ATTACHMENT A: Project Modification Request (PMR) Form

EATON WASH STORMWATER CAPTURE PROJECT Project Modification Supplemental Information

EATON WASH STORMWATER CAPTURE PROJECT BMP Performance Evaluation Memorandum

SUBJECT: Eaton Wash Stormwater Capture Project
BMP Performance Evaluation and Comparison Memorandum

Figure 1-1. Original Eaton Wash Project Concept Design (*Safe, Clean Water Program Feasibility Study, 2022*)

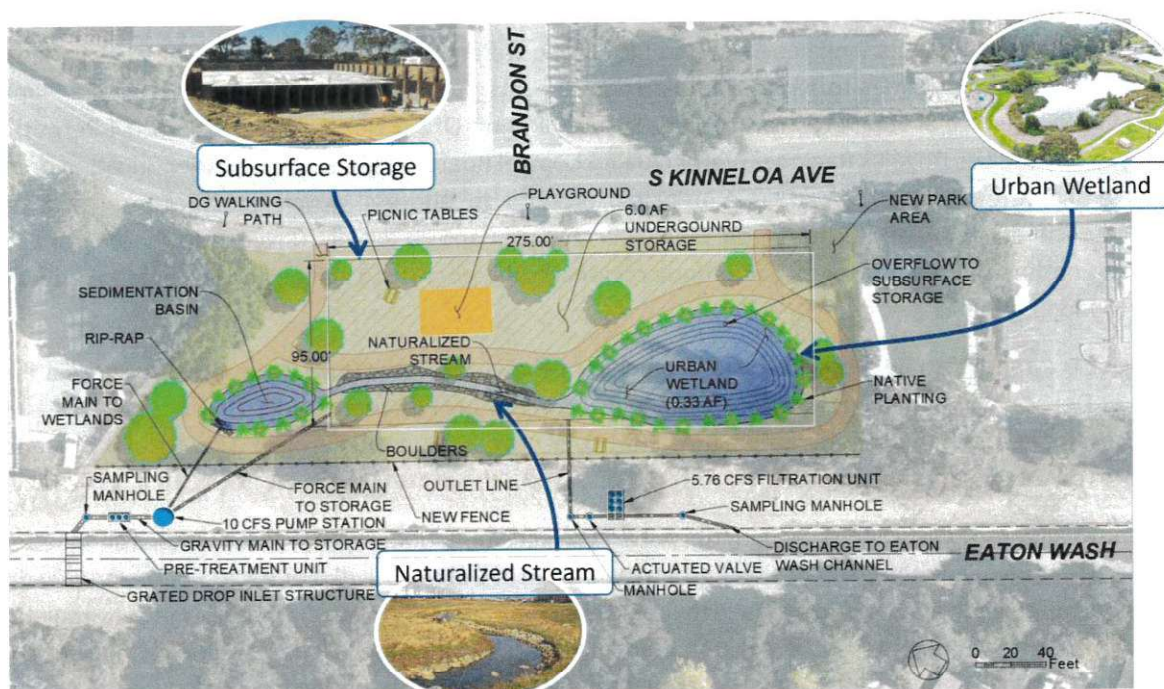
Figure 1-1 is the original concept design of the Kinneloa site approved and funded by the Safe, Clean Water Program in 2022. Stormwater and urban runoff is diverted from the bottom of the Eaton Wash channel and pretreated before entering the wet well. Water is then pumped from the wet well into the sedimentation basin or the 6 ac-ft underground storage. Water pumped to the basin will flow through a naturalized stream and enter the 0.33 ac-ft urban wetland treatment pond. All captured stormwater will pass through a 5.76 cfs filtration unit and discharge back to the Eaton Wash channel. Currently the Kinneloa Site consists of fill contaminated material that contains construction debris and scrap metal. A Land Use Covenant is on this property for commercial, industrial, or park uses.

Figure 1-2. Eaton Wash Project Site Location Map

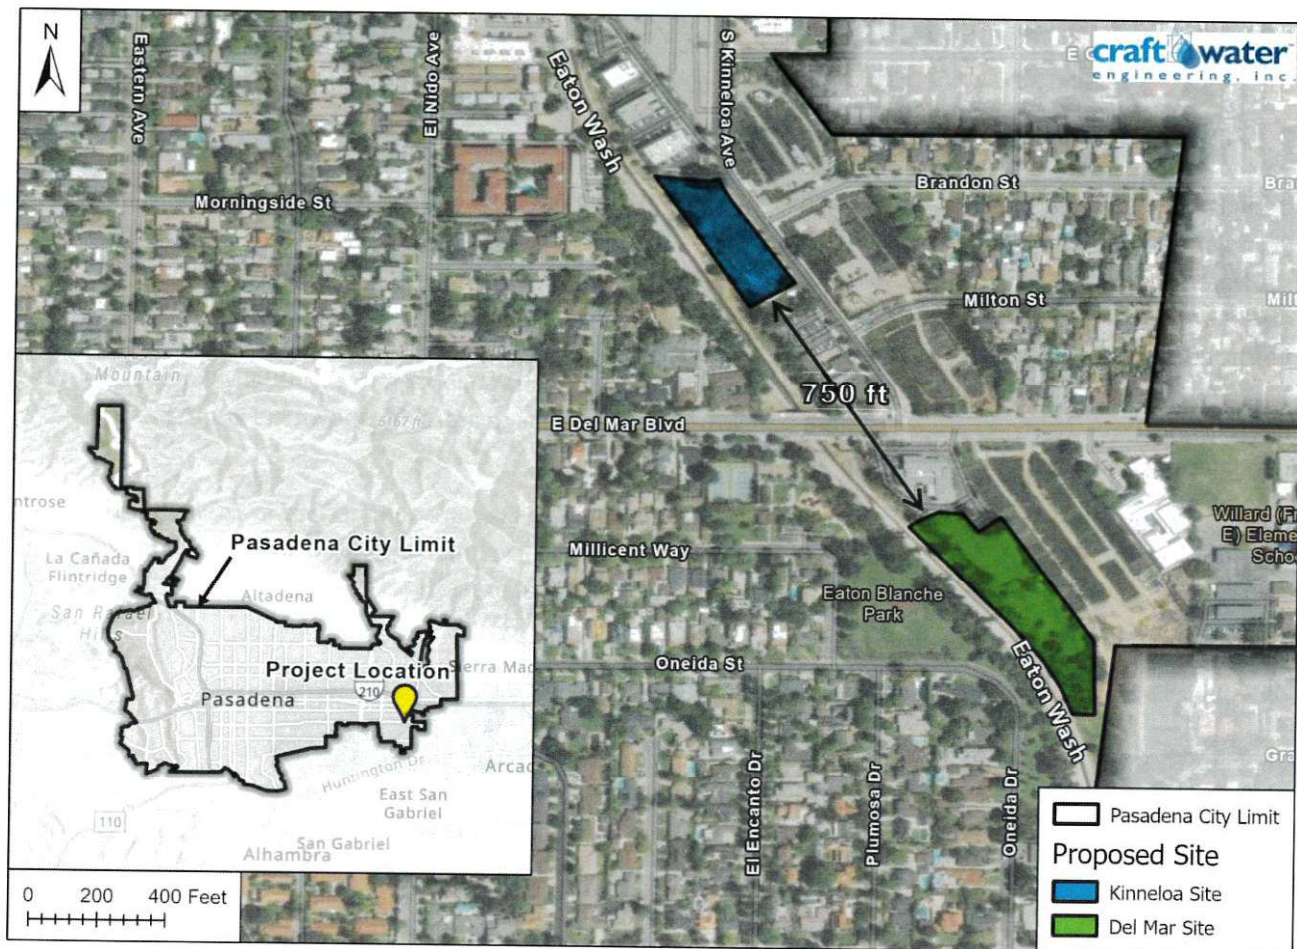
The two project site location alternatives were evaluated in this memo are described in **Table 1-1** and mapped in **Figure 1-2**.

- Flows from a City storm drain along E Del Mar Blvd will be captured by the Del Mar site but not the Kinneloa Site. Therefore, the Del Mar BMP has the **potential to treat slightly more runoff and pollutants**.
- Infiltration of captured stormwater is prohibited at the Kinneloa site due to the existing soil contamination. Based on preliminary assessments, infiltration is feasible at the Del Mar site, allowing the Del Mar site BMP to **treat more runoff and pollutants through infiltration**.

Figure 3-3. 85th Percentile 24-Hour Storm Routing (Left: Kinneloa; Right: Del Mar)

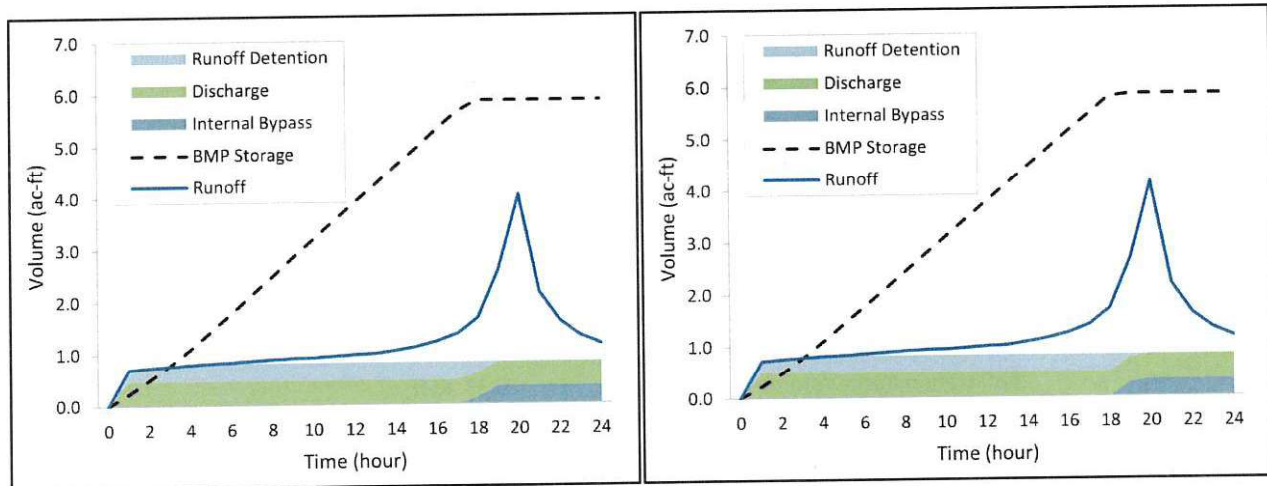
Figure 3-3 illustrates the 85th percentile 24-hour design storm routing for both sites. The project will be able to divert all the flows before runoff in Eaton Wash exceeds 10 cfs. The storage keeps filling until it's full in hour 17-18. The filter works at full capacity starting from the 1st hour until the end of the 24-hour storm. Because the 85th storm peak flow is much higher than the diversion rate, the peak of the storm will not be treated.

Figure 1. Overall approach to compare runoff water quality from swept and unswept pavements.

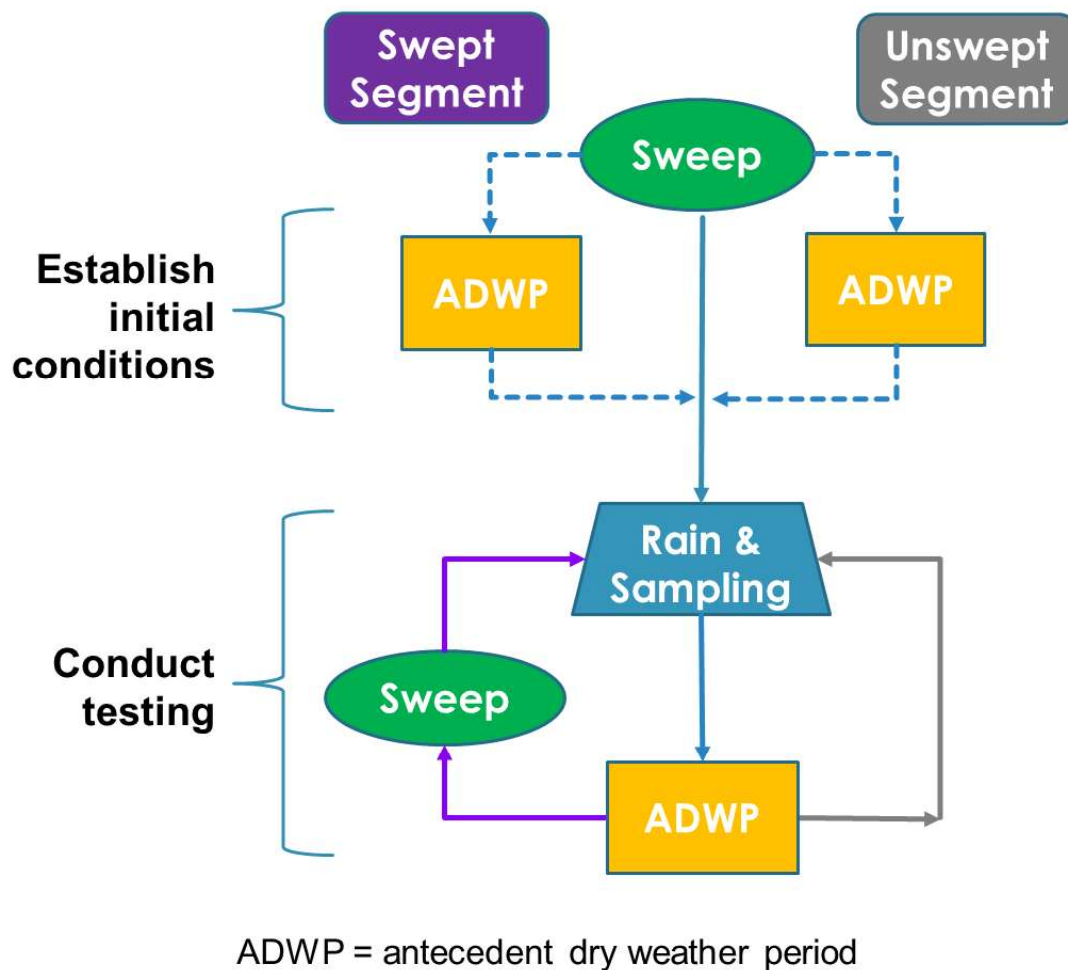
The overall approach (Figure 1) begins with establishing similar initial pavement conditions by sweeping all pavement segments to be tested according to a set antecedent dry period (ADWP). After the end of the ADWP, simulated rainfall is applied to unswept and swept pavements, and samples are collected. Subsequently, only the designated swept pavement segment is swept again after the next ADWP has elapsed. Rainfall is again applied to both swept and unswept pavements, with sample collection. The cycle is repeated as needed.

The RFG will be applied consecutively over three adjacent pavement segments to create a unique test per pavement condition. Simulated rainfall will be applied for 15-min over each segment. The duration of rainfall has been determined as a balance between providing adequate time for pollutant wash-off, an ability to test multiple segments to constitute a single event for a pavement condition, and testing multiple events in a single day. Runoff will be captured along the gutter using a peristaltic pump, and collected in a clean 200-L polypropylene barrel to create a whole-of-event composite sample per test event per pavement condition. The composite sample will be aliquoted for subsequent laboratory analysis.

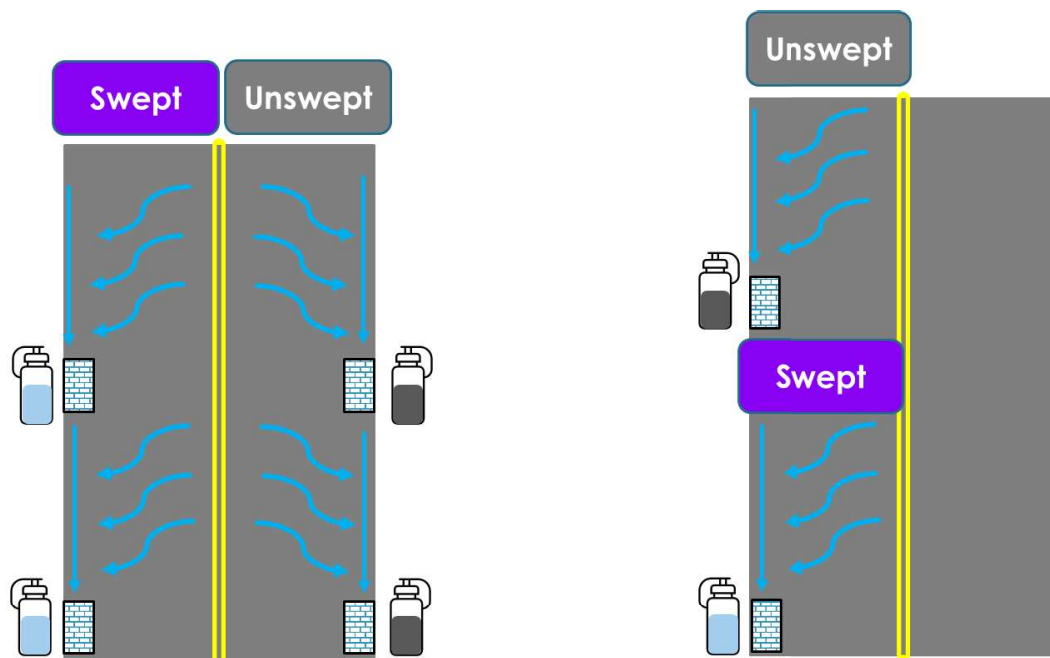
At least four pairs of unswept and swept pavements will be tested at each location. Up to two test pairs (4 individual rainfall events) can be conducted in a single test day if there are multiple segments available for each pavement condition, for the example as depicted in the site configuration on the left of Figure 3. Alternative approaches to testing may be developed to conduct multiple tests in a single day of a single pavement condition at a time (i.e. conduct 4 tests on swept street segments in a single day, and return another day to conduct 4 tests on unswept street segments).
